**KIRKLEES METROPOLITAN COUNCIL**

**UPDATE OF LIST OF PLANNING APPLICATIONS TO BE DECIDED BY**

**PLANNING SUB-COMMITTEE HEAVY WOOLLEN**

**1 JUNE 2018**

## Proposed Visibility Splay and Sightlines

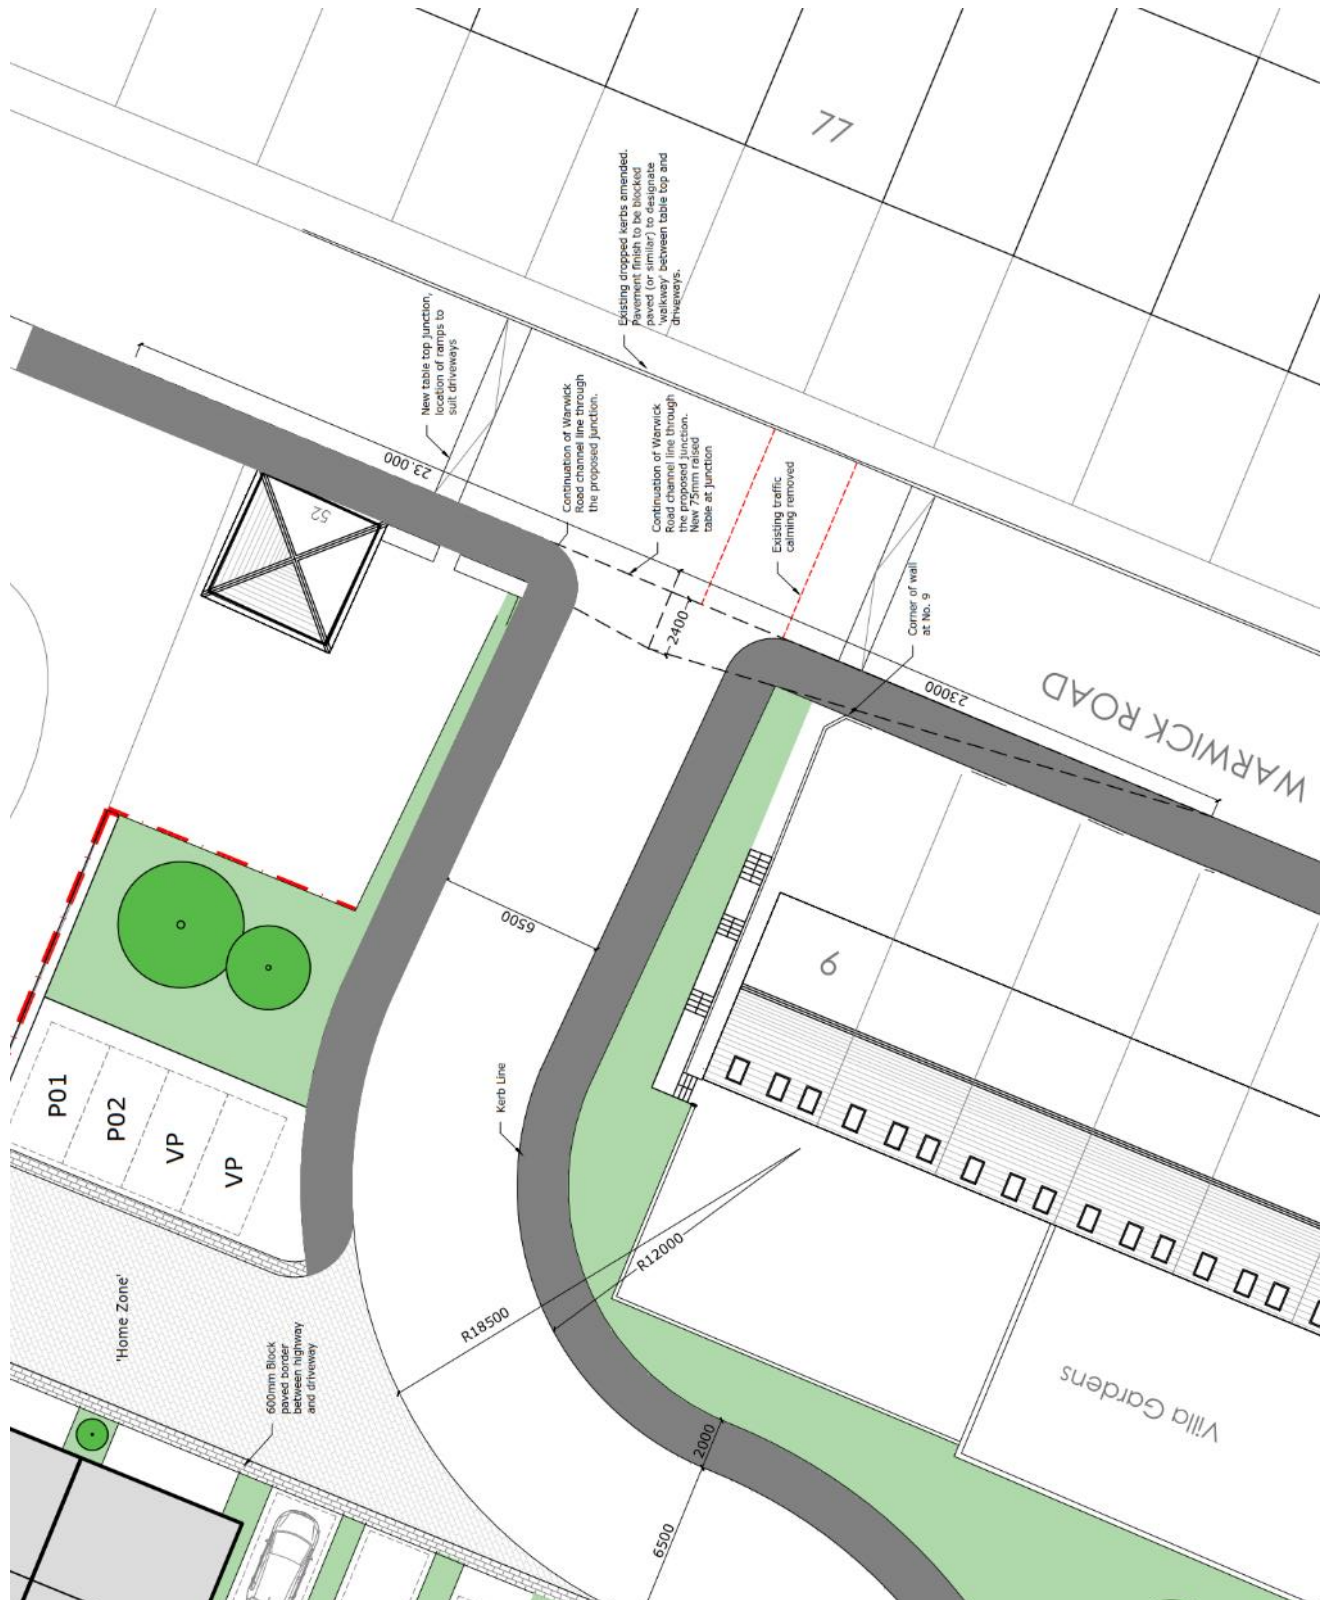
Paragraph 3.119 of the Leeds guide gives the Y-distances to be used for different 85%ile speeds. For a 15mph speed the Y-distance is 23m.

The x-distance should be 2.4m measured from back the give way line or an imaginary line if no such markings are provided. Using the continuation of the Warwick Road channel line through the proposed junction to set back the 2.4m x-distance and plotting a splay for the 23m y-distance the splay is in front of the corner walls of the properties on both sides of the junction.
